## THE RESERVE AT CRIMSON RIDGE PHASE 2A

**CLUSTER SUBDIVISION**

LOCATED IN THE NORTHEAST QUARTER OF SECTION 10, AND THE SOUTH HALF OF SECTION 3
TOWNSHIP 6 NORTH, RANGE 1 EAST, SALT LAKE BASE AND MERIDIAN,
WEBER COUNTY, UTAH, JANUARY 2021

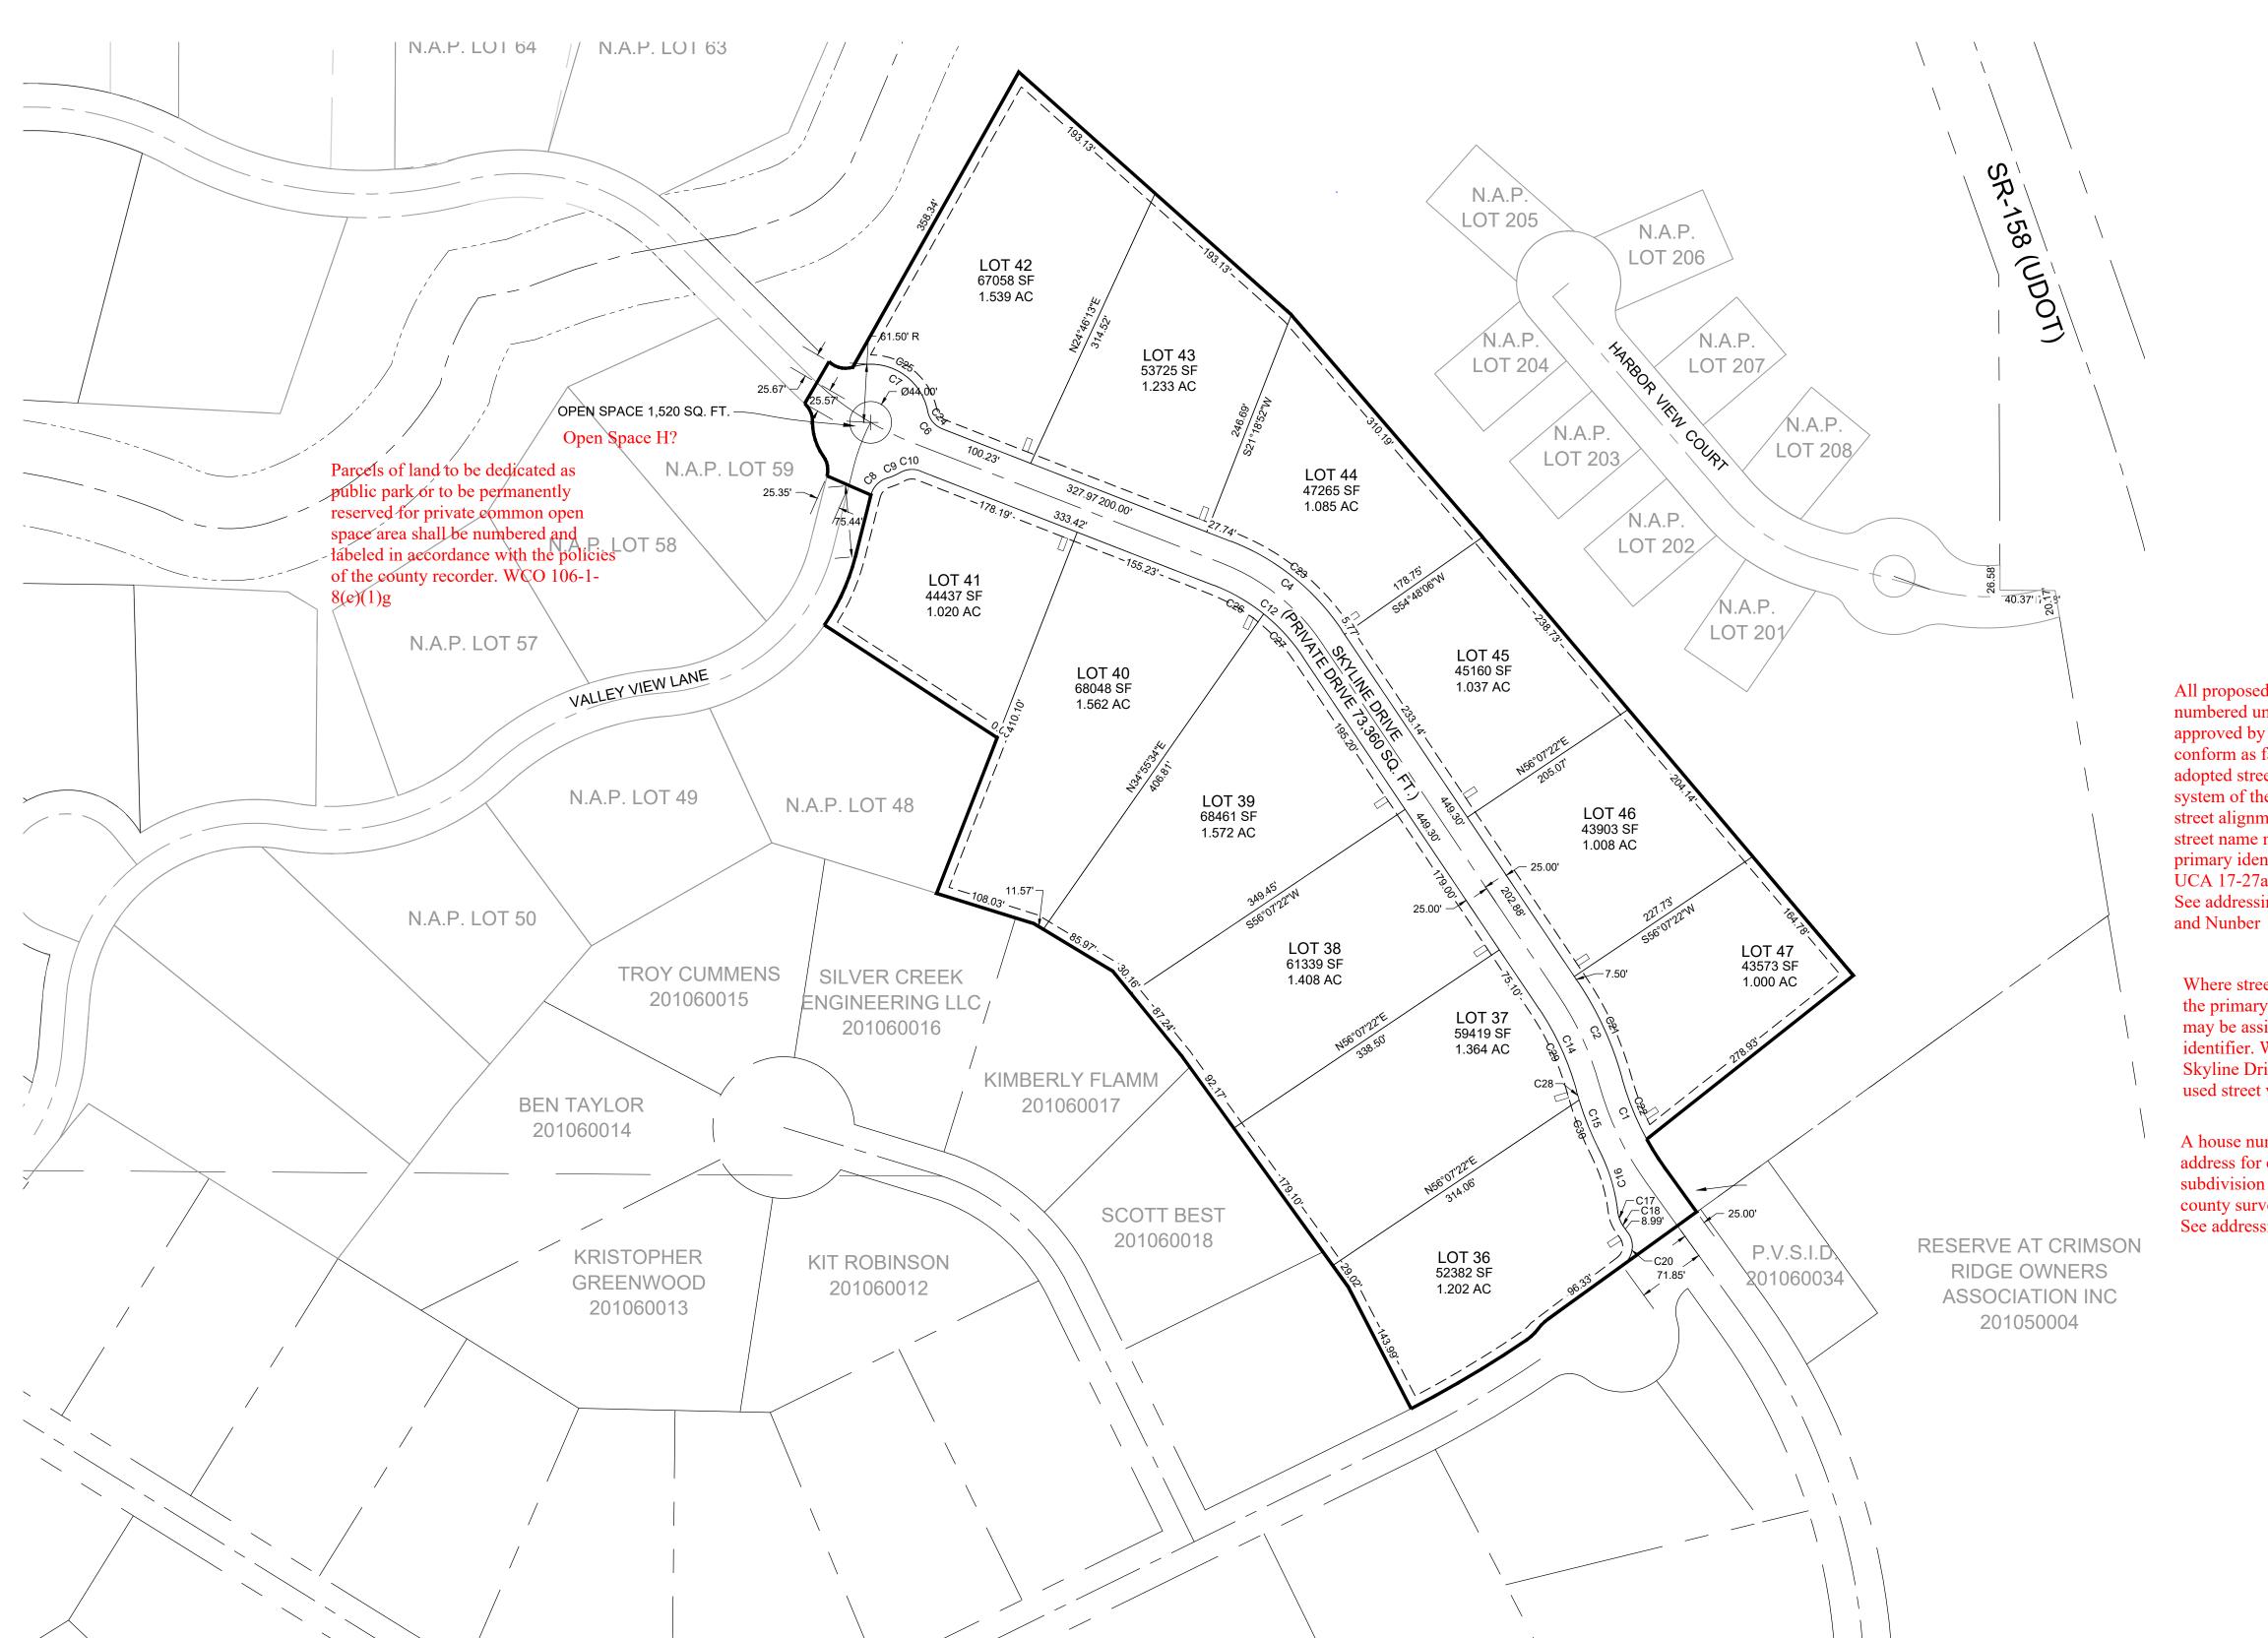
All proposed streets shall be numbered under a definite system approved by the county surveyor and conform as far as practicable to the adopted street naming and numbering system of the county. Unless there are street alignment situations where a street name may be better utilized as a primary identifier. WCO 106-1-8(c)(1)e; UCA 17-27a-603(1)(c)
See addressing review for street name

Where streets are given a number as the primary identifier a street name may be assigned as a secondary identifier. WCO 106-1-8(c)(1)e Skyline Drive has already been used street will have to be renamed

A house number indicating the street address for each lot within the subdivision shall be assigned by the county surveyor. WCO 106-1-8(c)(1)f See addressing review for house #
